**BLOOMINGTON PLAN COMMISSION
STAFF REPORT
Location: 105 S. Pete Ellis Drive**

**CASE #: PUD-16-21
DATE: June 14, 2021**

REQUEST: The petitioner is requesting to amend the District Ordinance and Preliminary Plan for a 3.2 acre Planned Unit Development. And requesting a waiver of second hearing.

SITE PLAN COMPARISON
05/03/2021

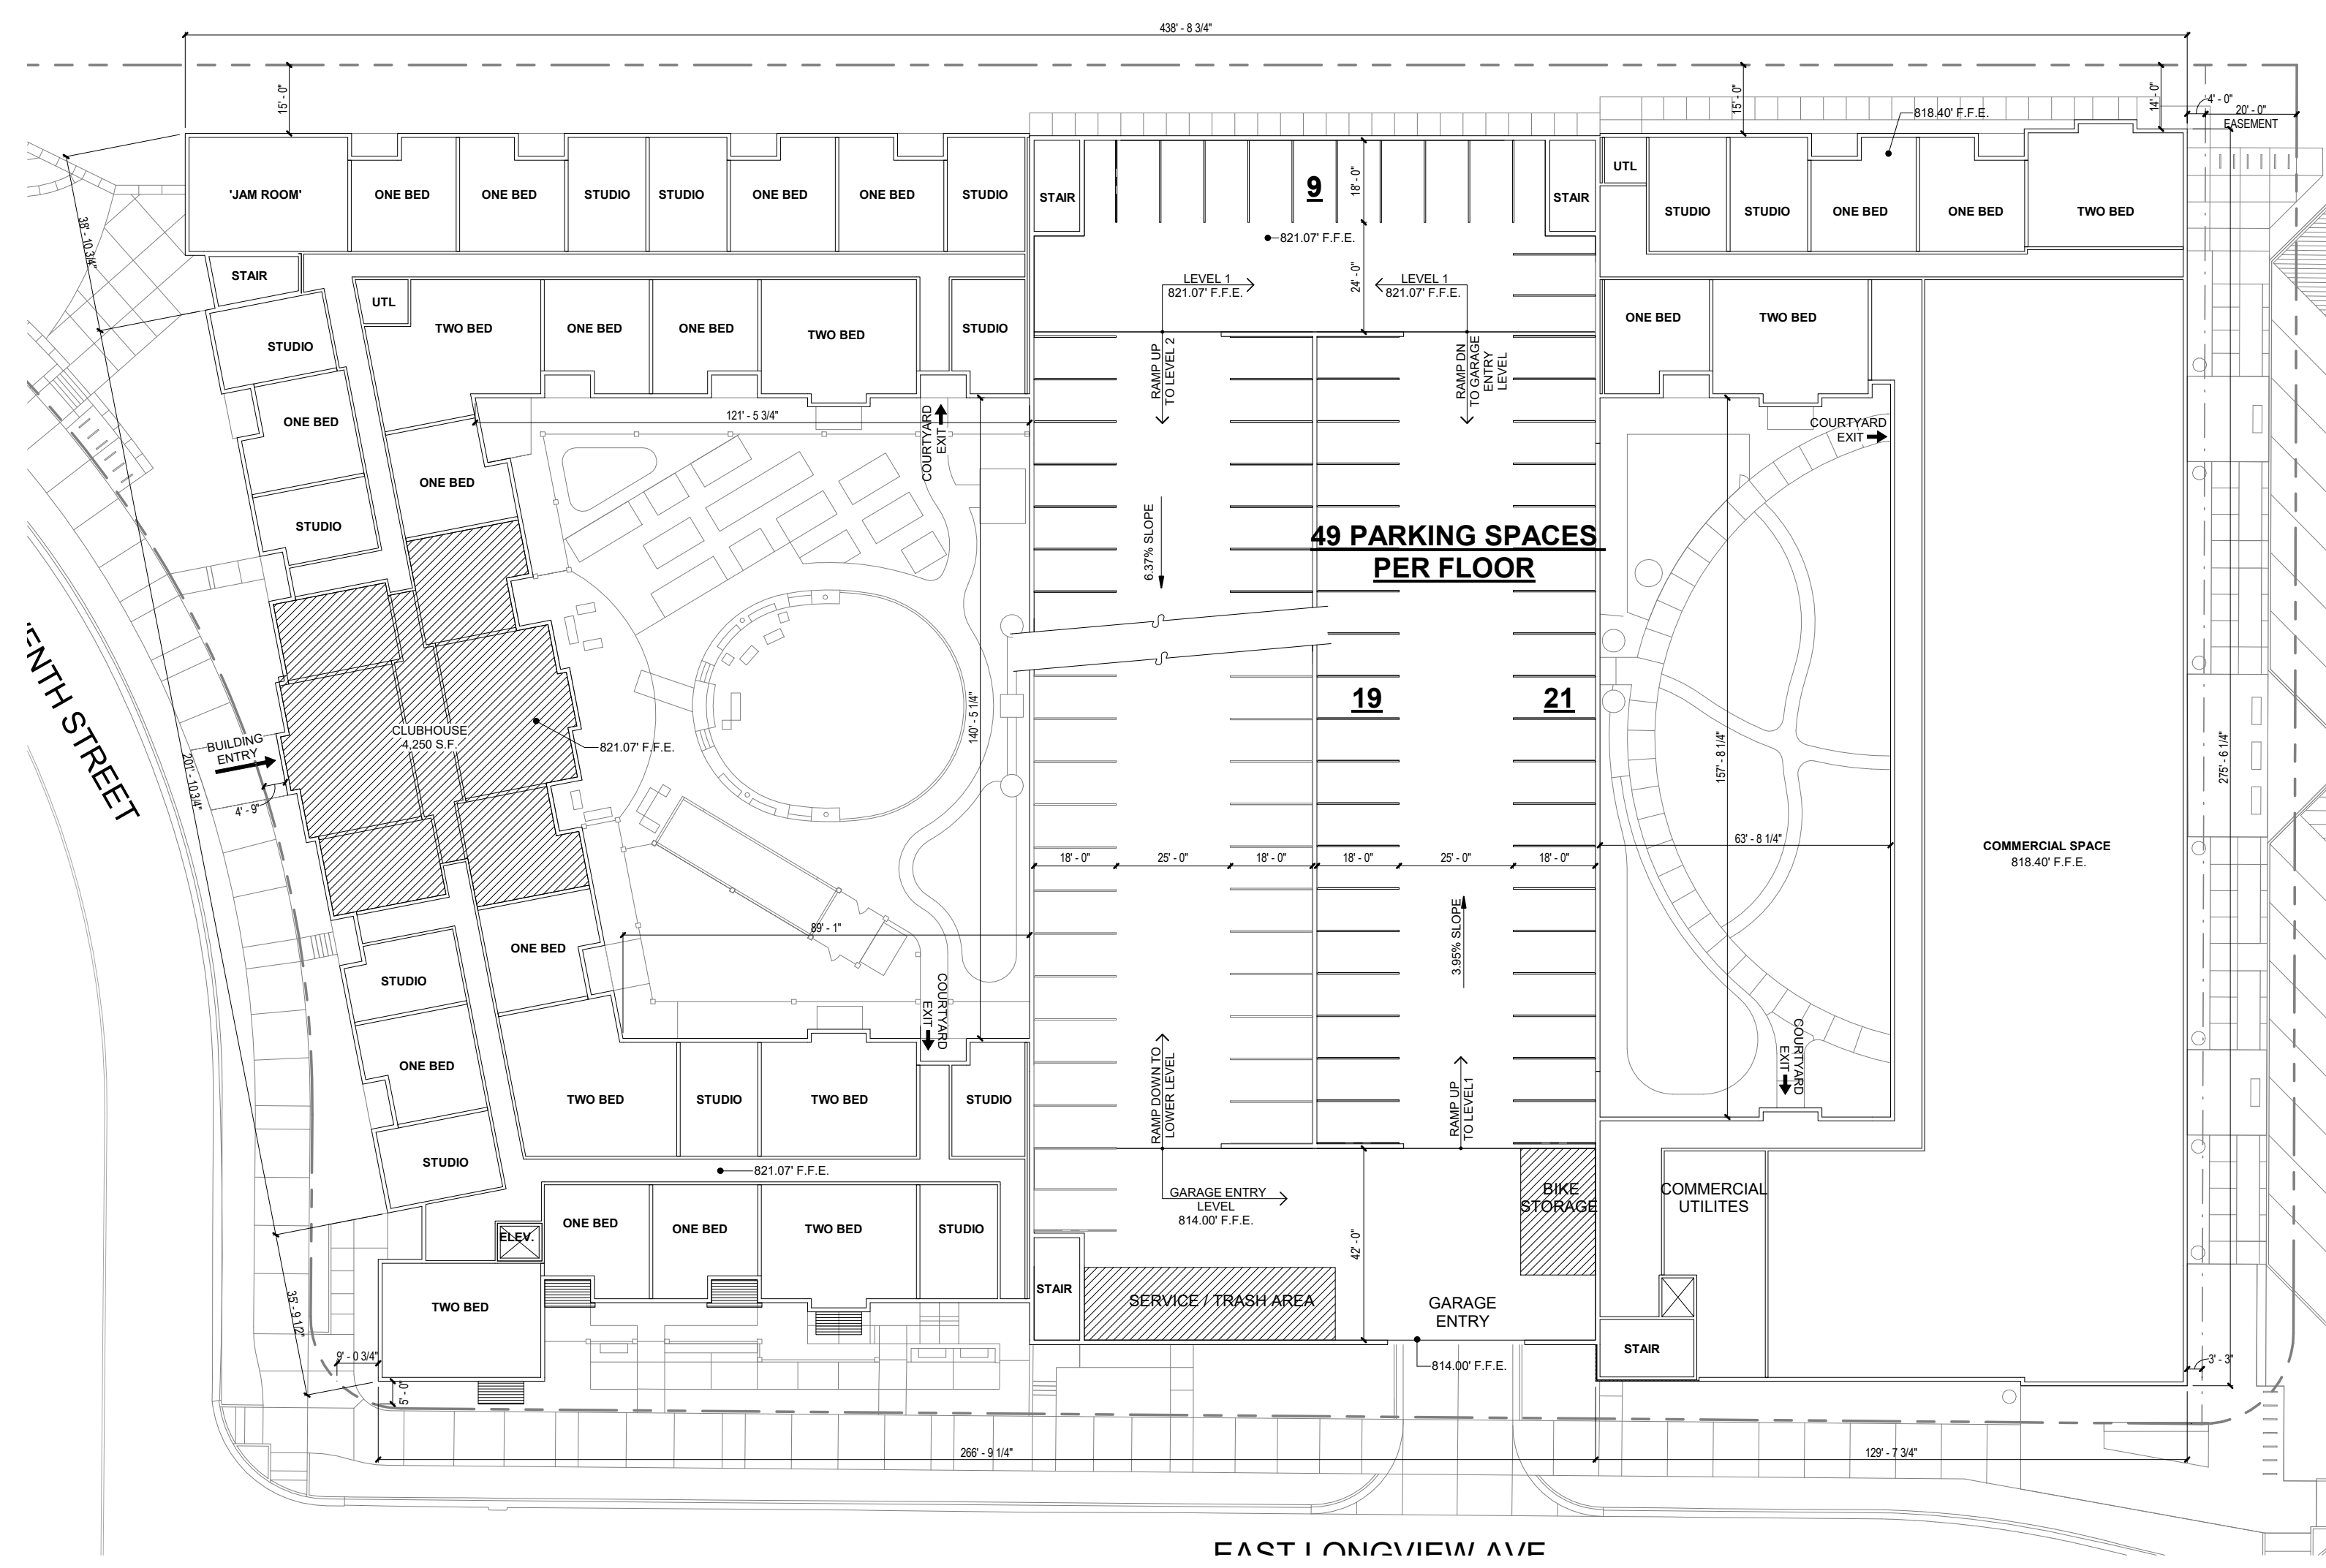
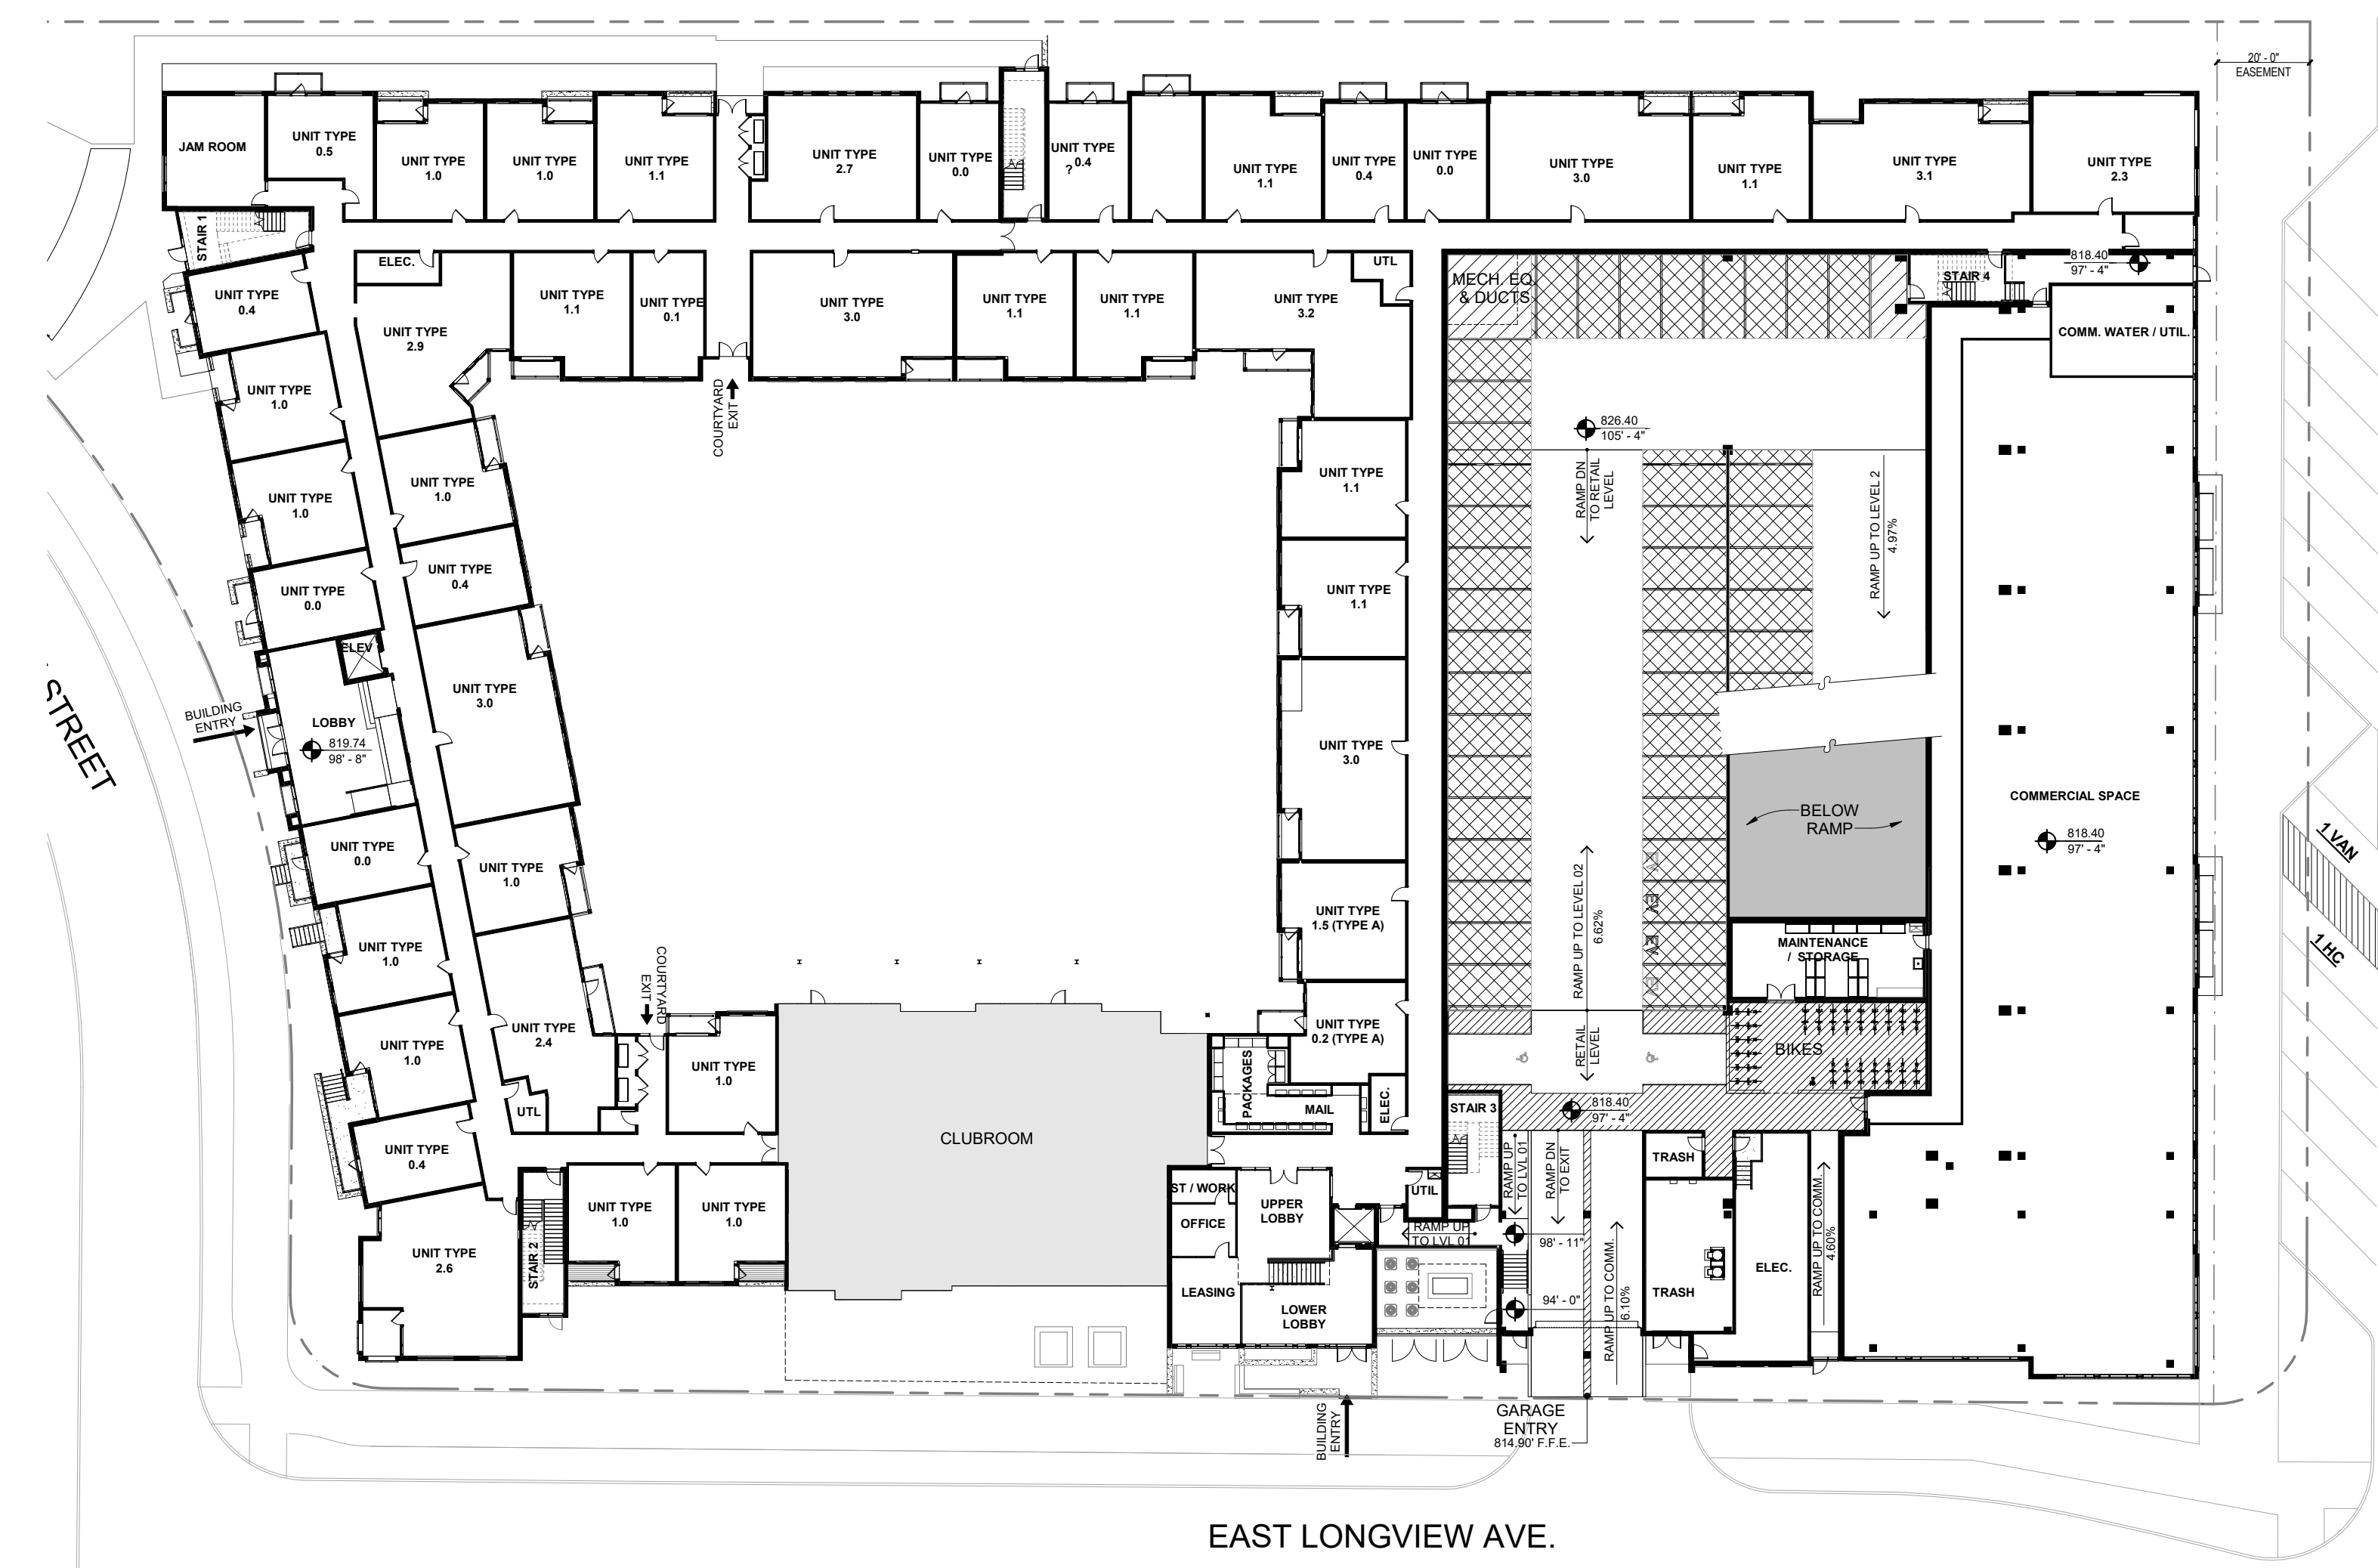
- 1) **Proposed Change:** Shifting the garage and using residential units to meet the requirements under Reasonable Condition #03 to mask the garage.

Petitioner’s Response: Petitioner is proposing to shift the parking structure to allow for single (enlarged) courtyard and wrap the garage completely with residential units in lieu of “artistic or green screening” as described in Reasonable Condition #03. Petitioner proposes that the intent of the reasonable condition to “improve the visual appeal of the exterior of the parking garage” is met by completely wrapping the garage with the architectural façade (effectively eliminating the garage from view). Further, this will provide for a courtyard space that will allow for plantings to grow, an improved resident amenity, and better function of and between the commercial space, residential leasing office, and garage.

NOT TO SCALE
SITE PLAN
05/03/2021

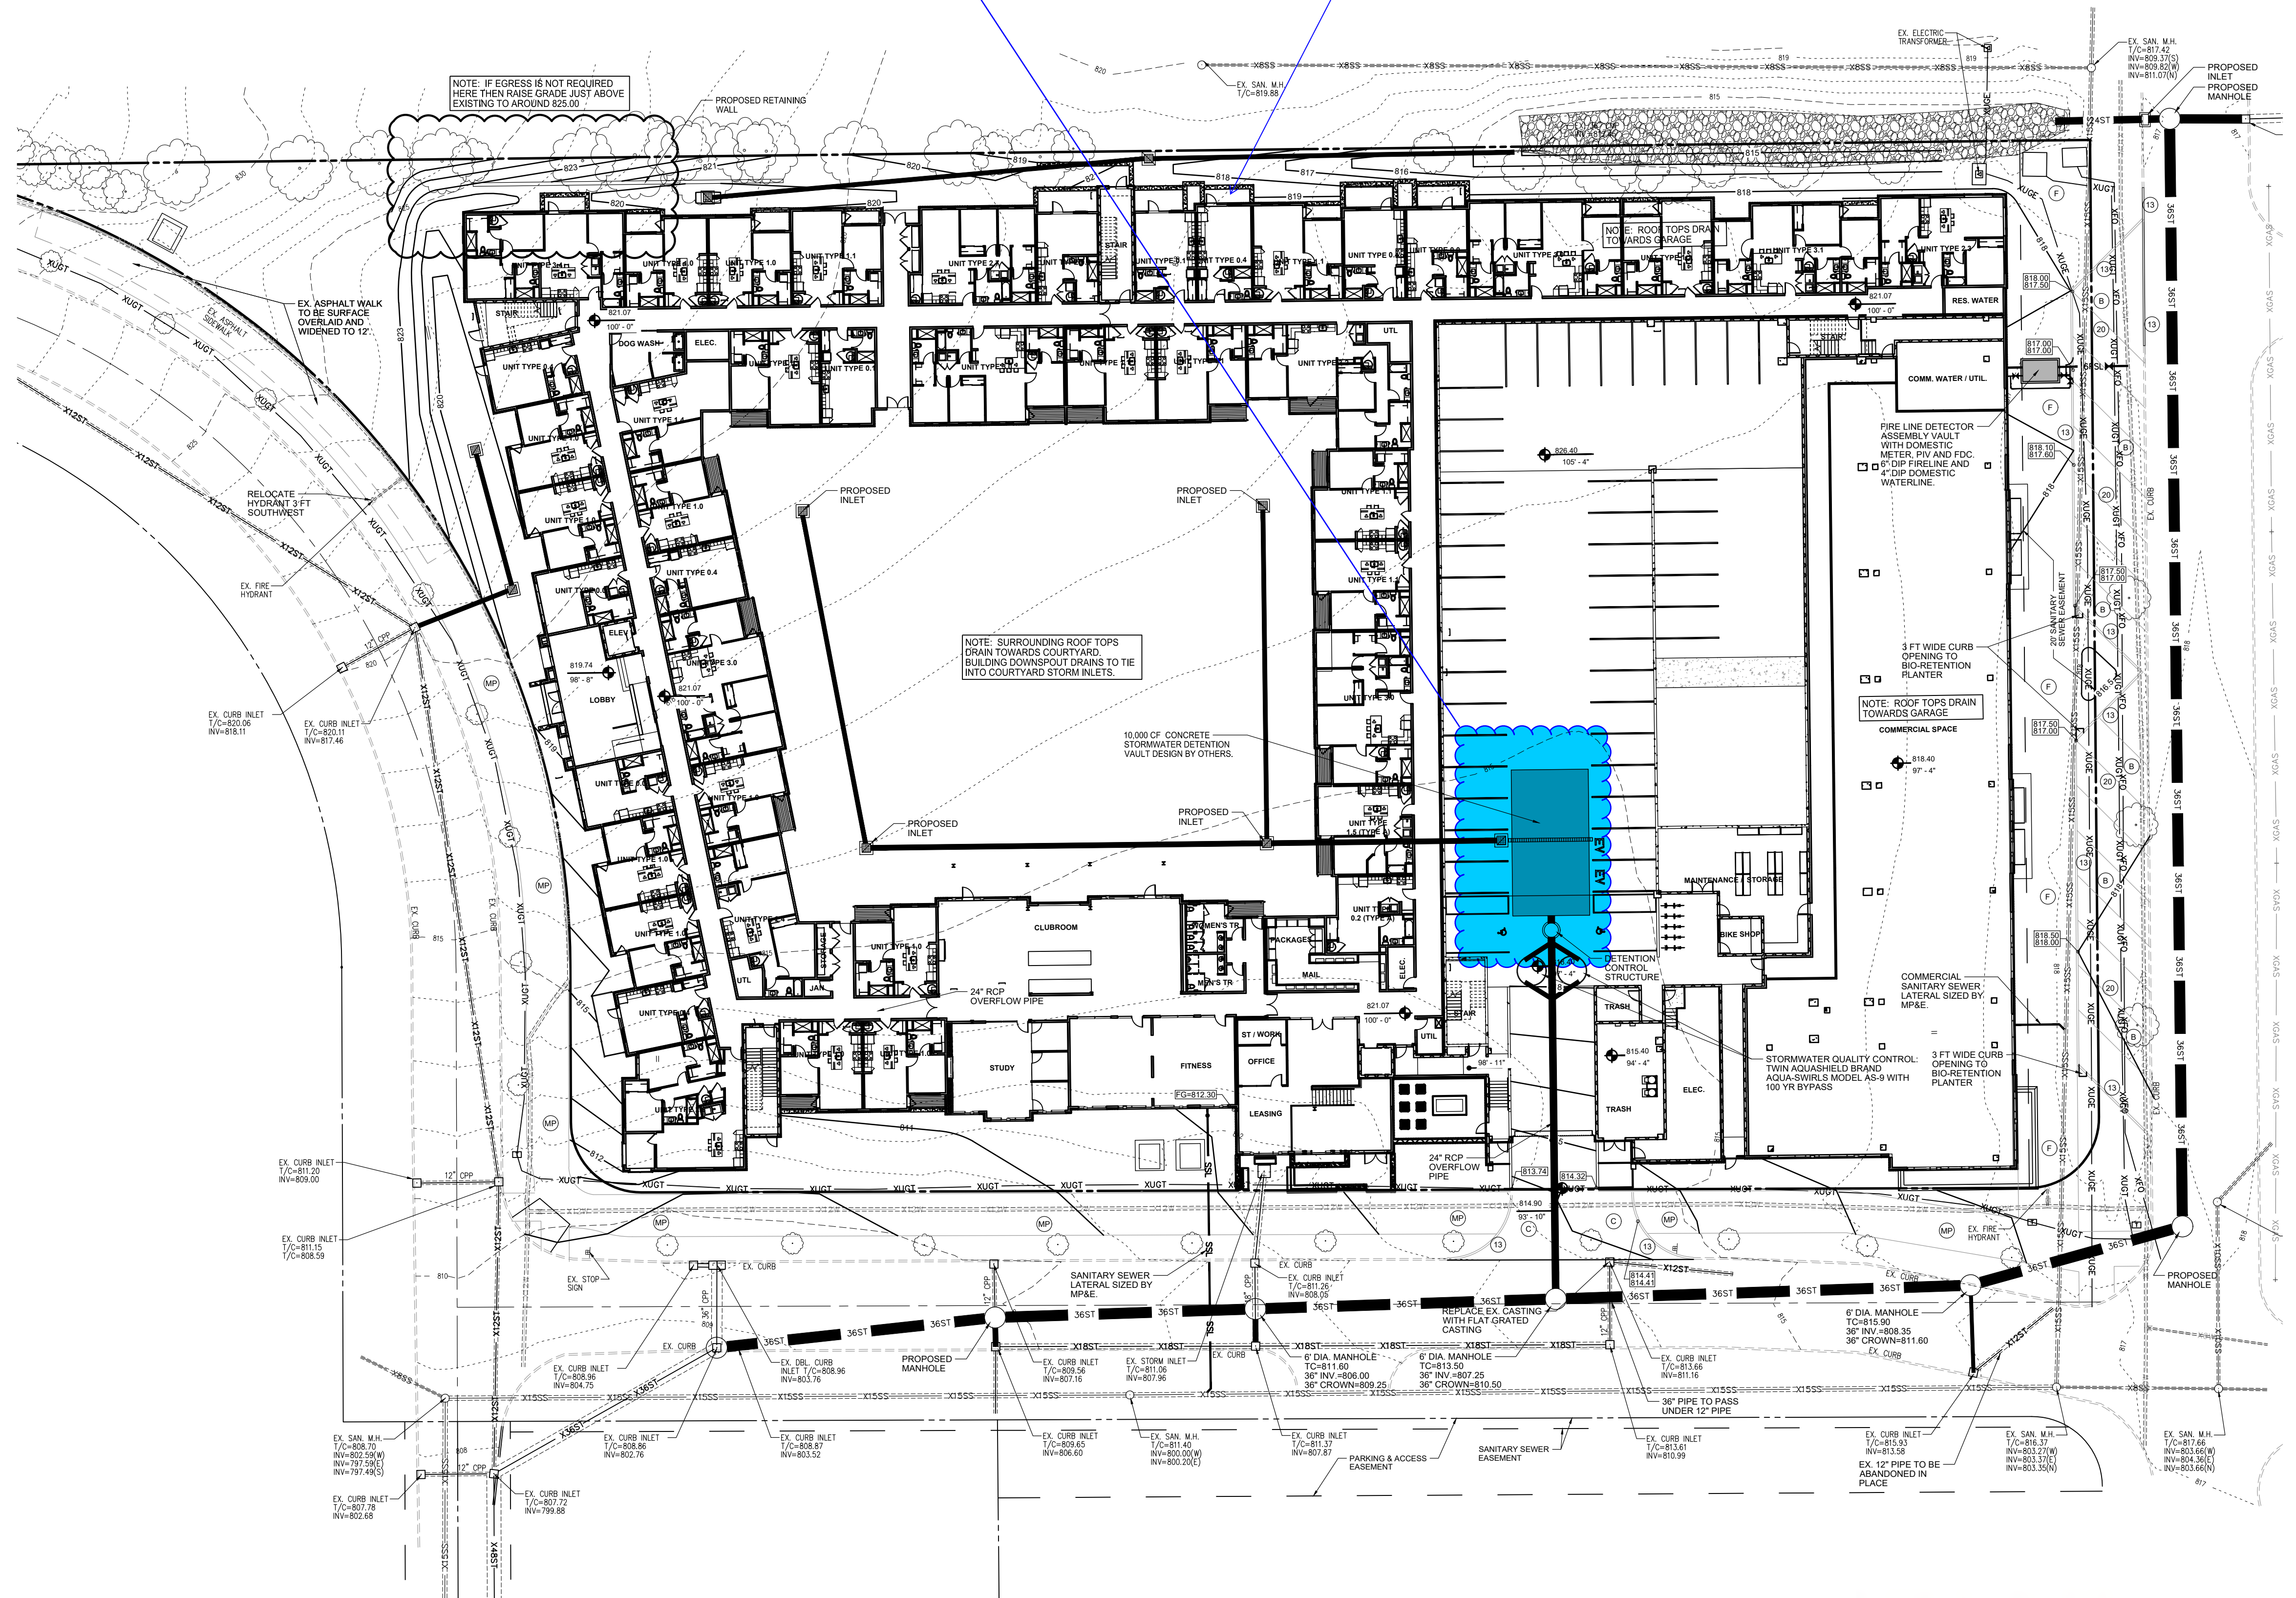
Petitioner is currently investigating solutions to allow for stormwater detention in the courtyard

Petitioner will omit hanging balconies along the north side of the building as described in Petition
